AMENDED

PROJECT: Ravenscar Tearooms
1 Station Sq Ravenscar

Drawing: Rebuild existing Lean-to
Existing and Proposed
Plans and Elevations

DRAWING No: D11185-02
REV: D

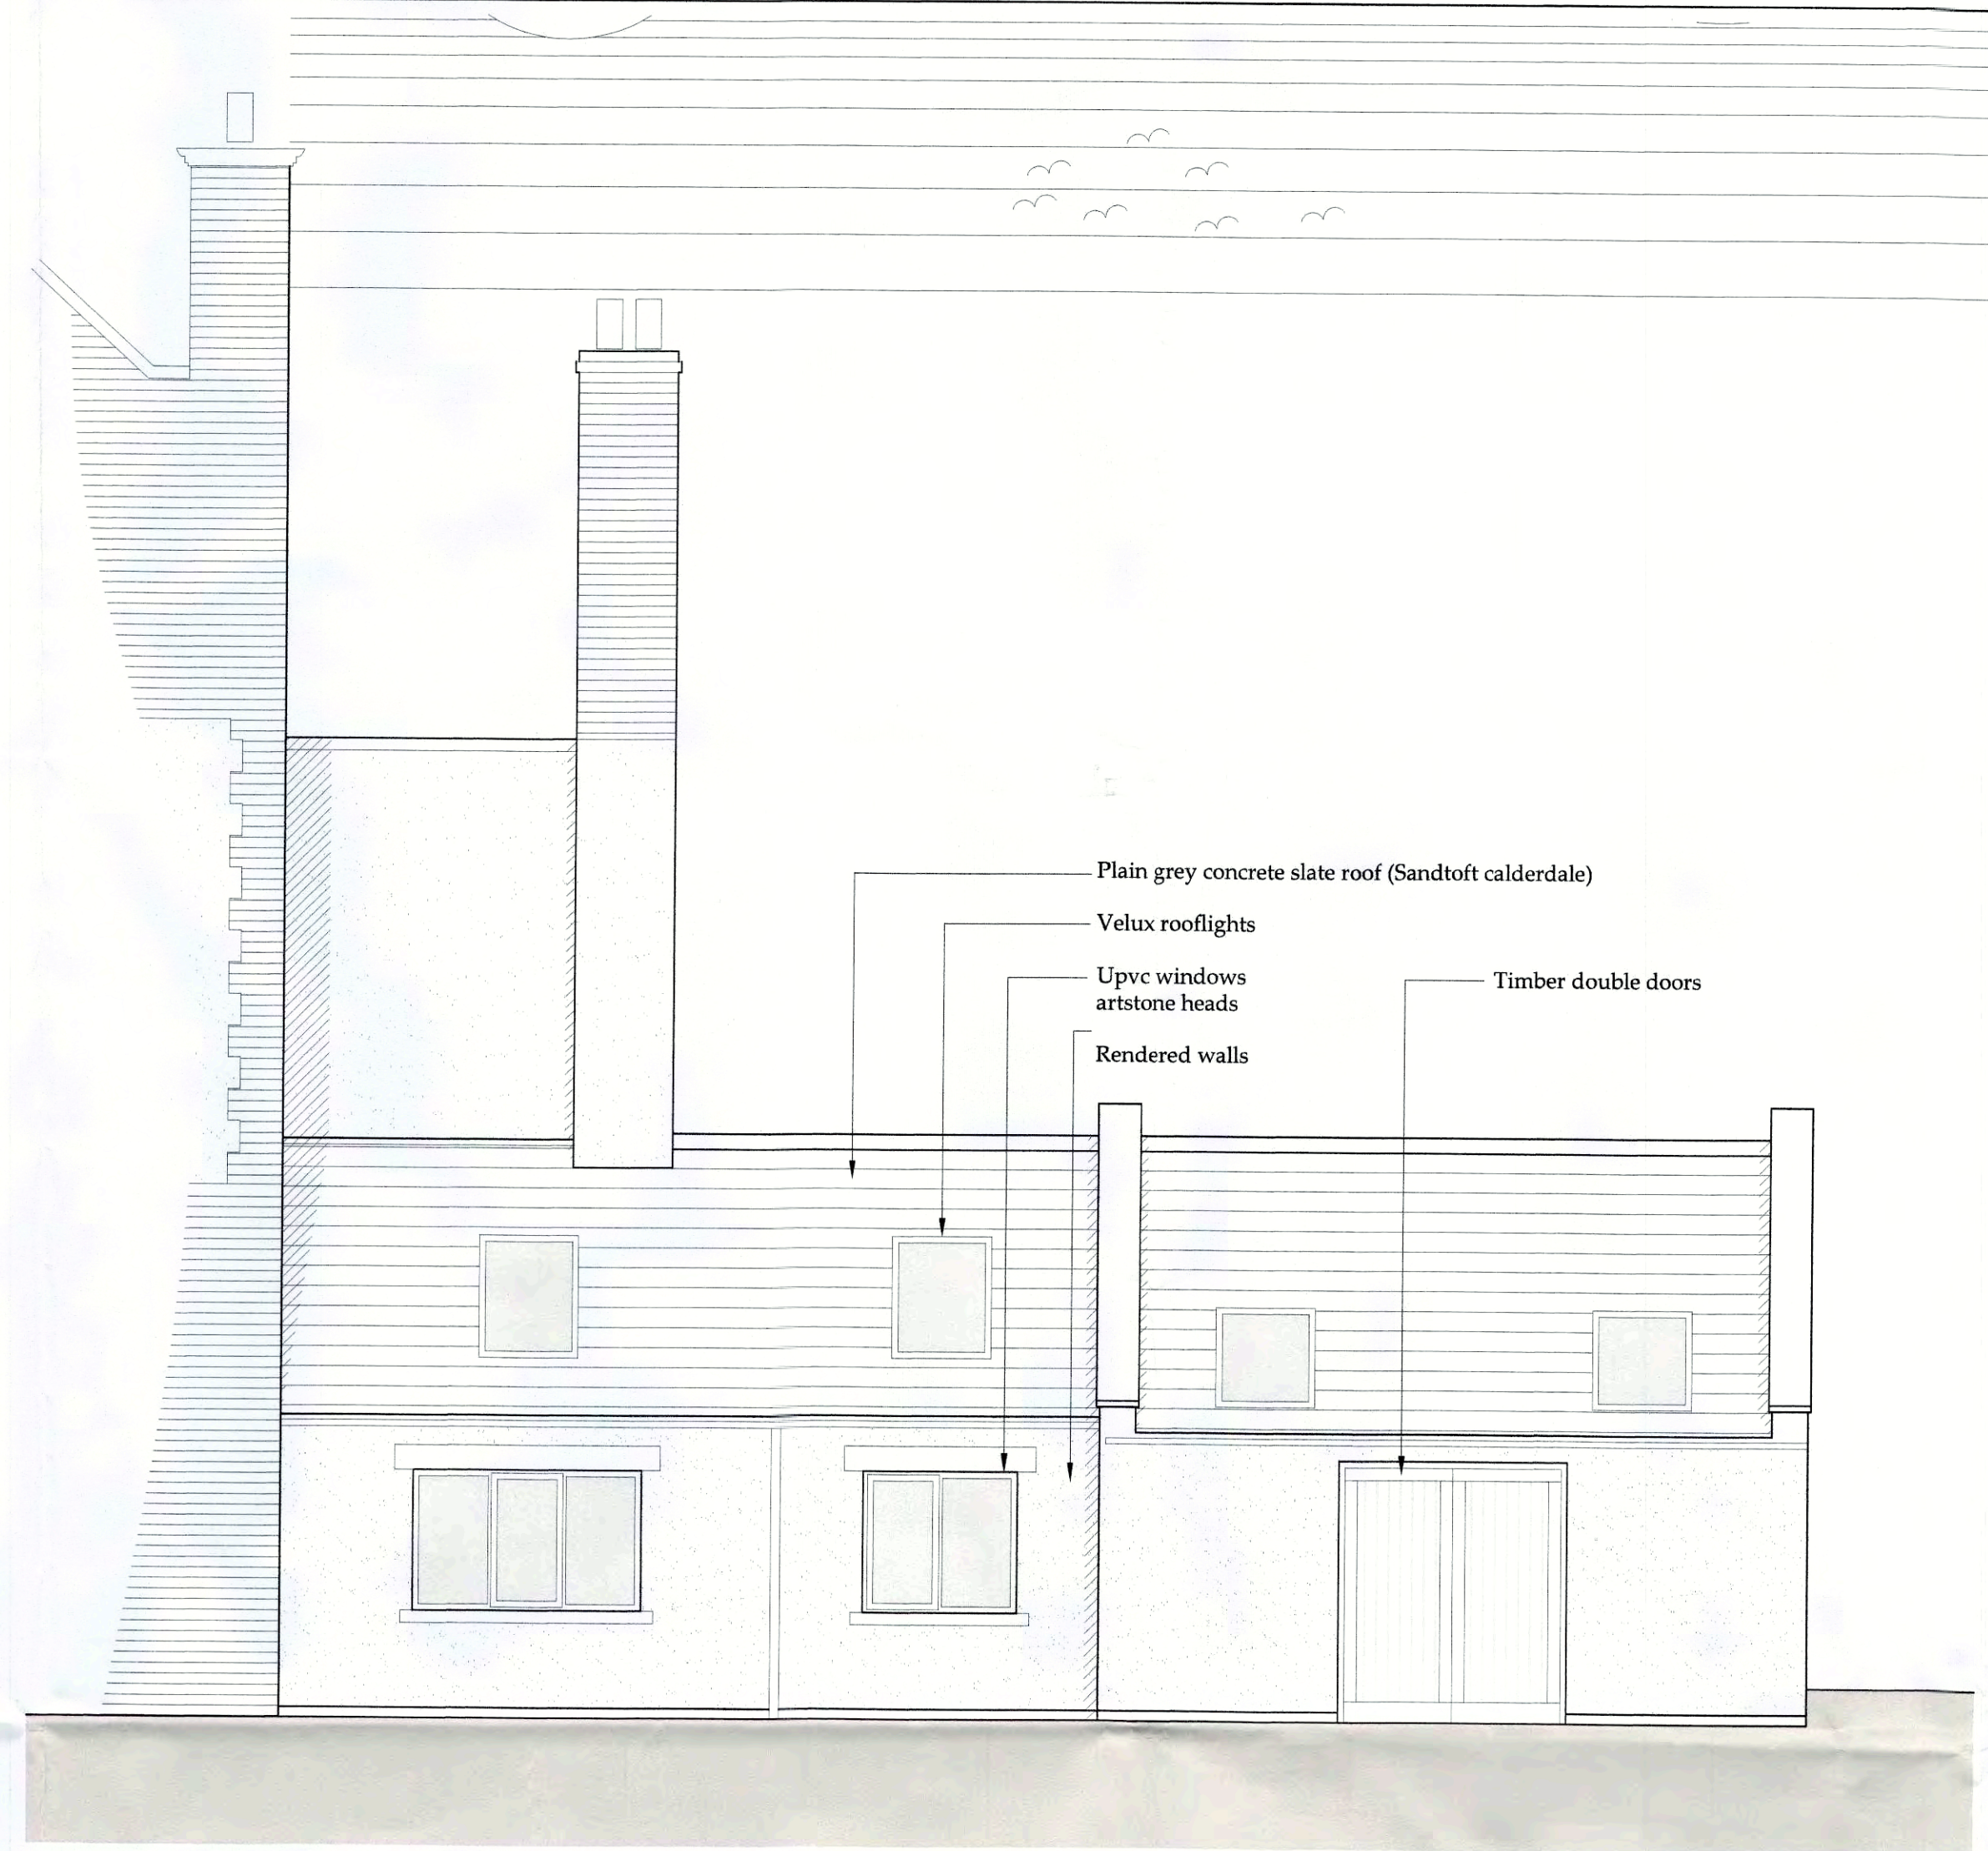
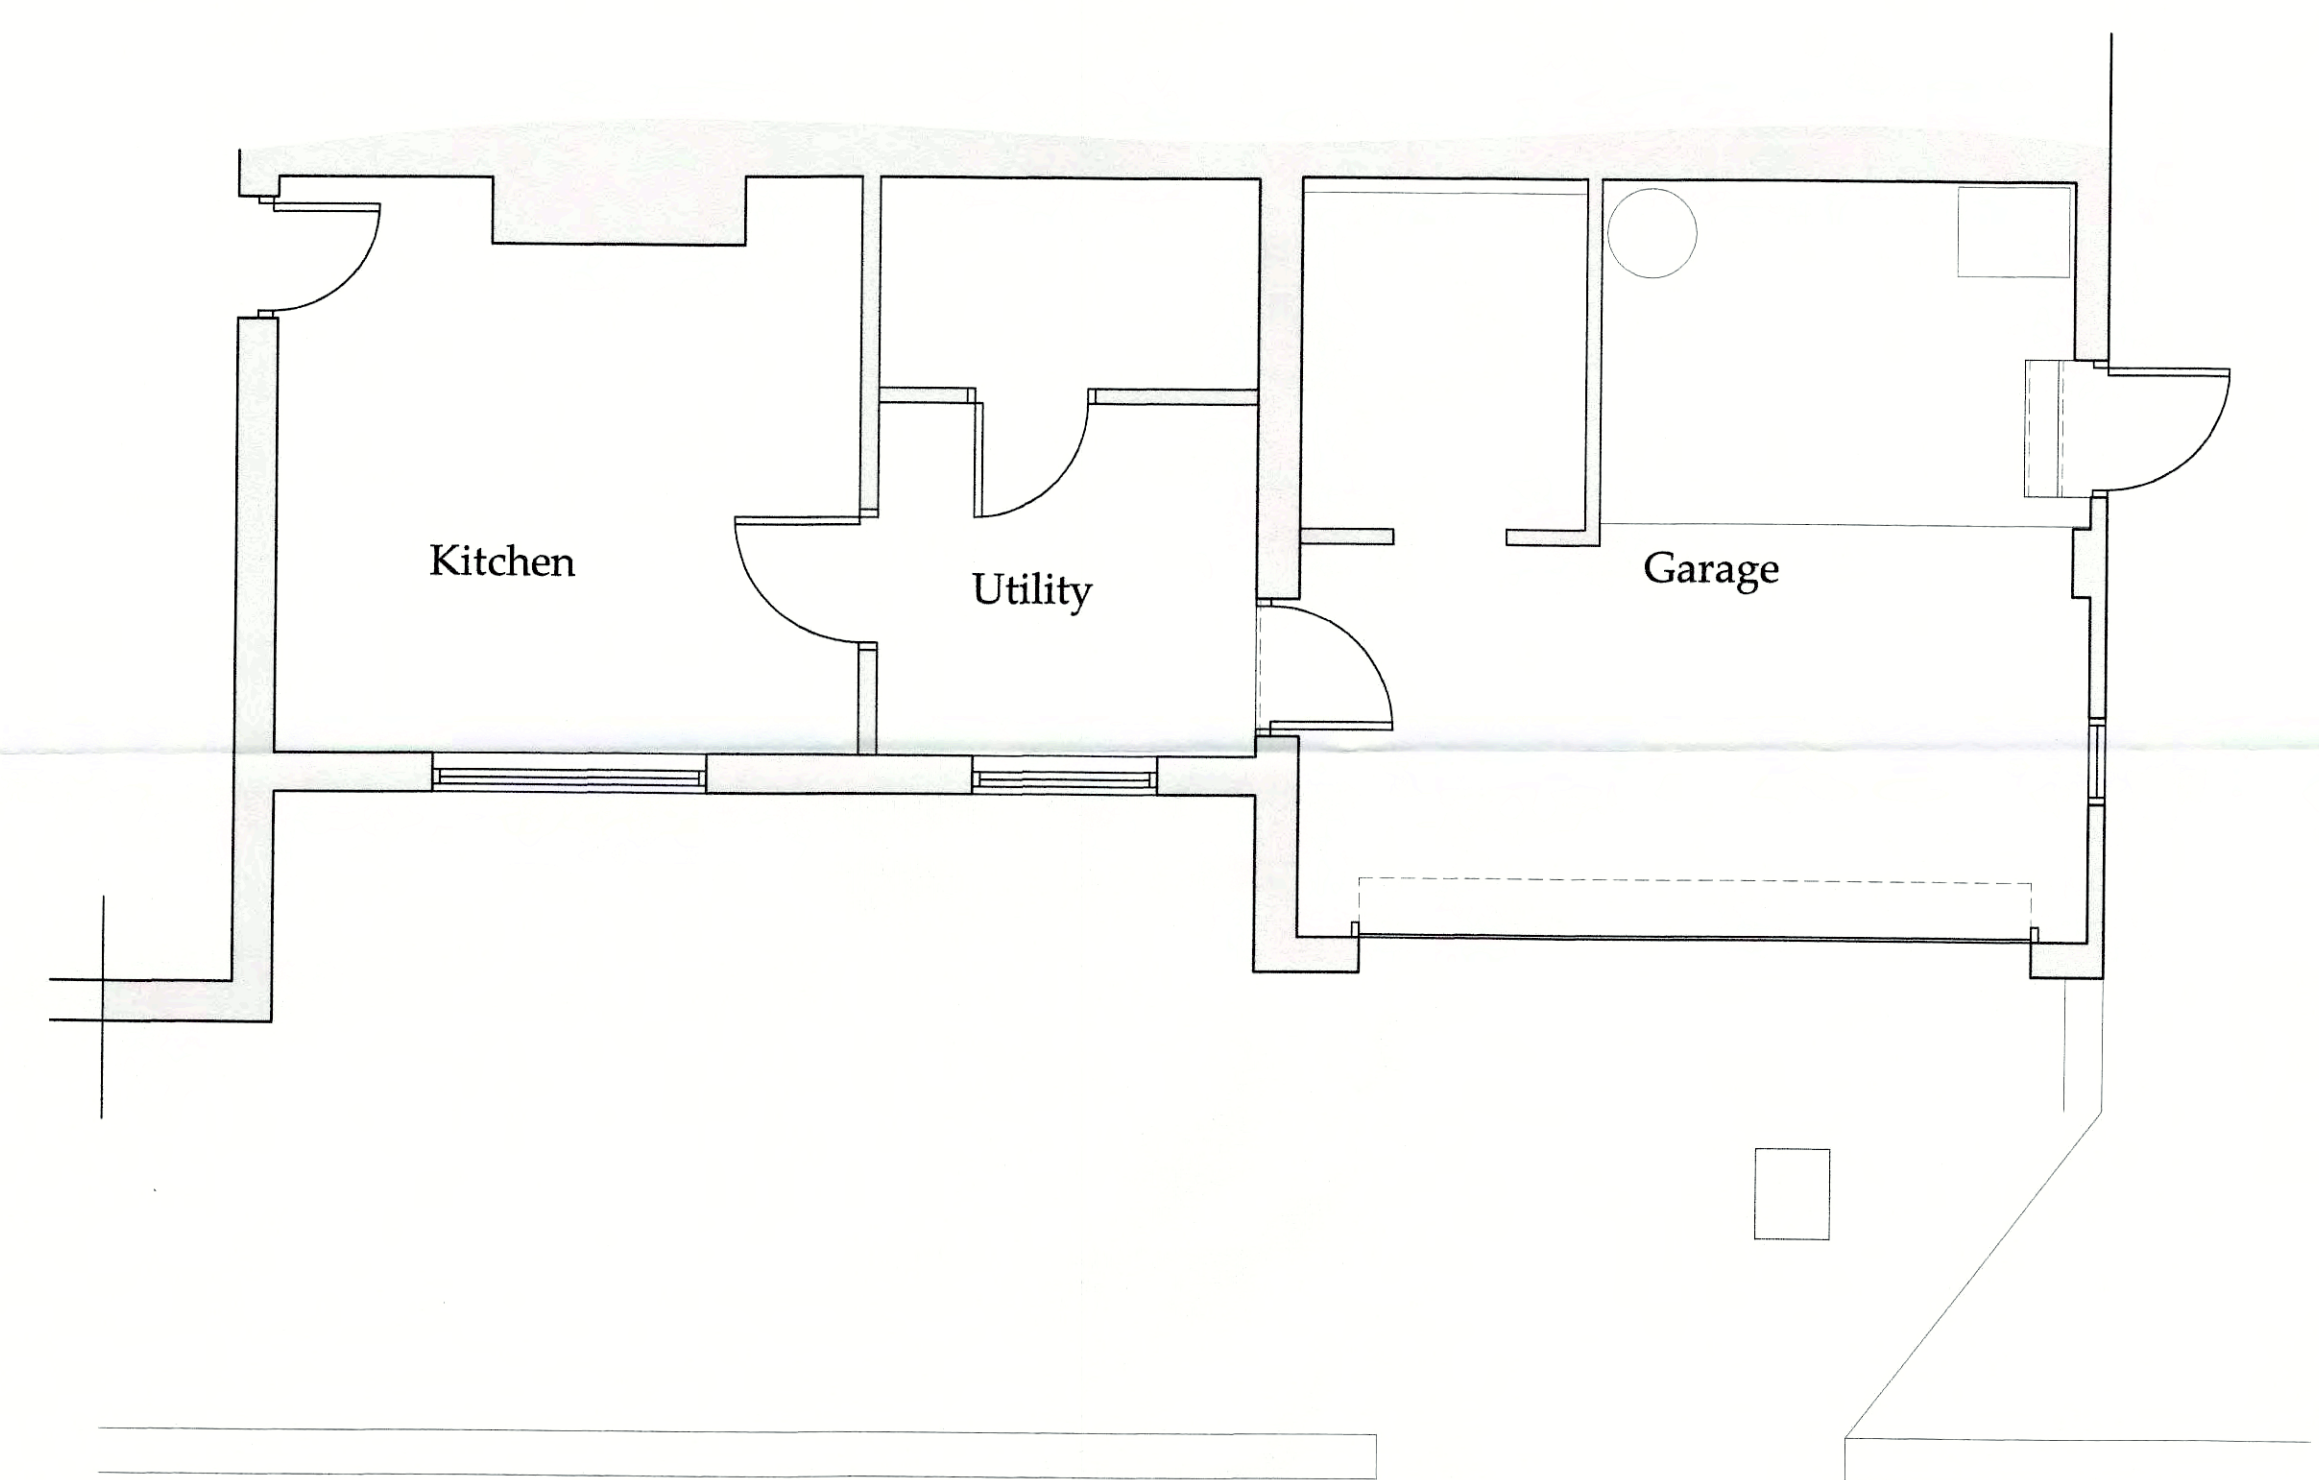
D	19/07/17	NID	Set back kitchen
C	22/06/17	nld	rooflight reduction and doors
B	22/05/17	nld	Client amends
A	08/05/17	CE	Issued for approval
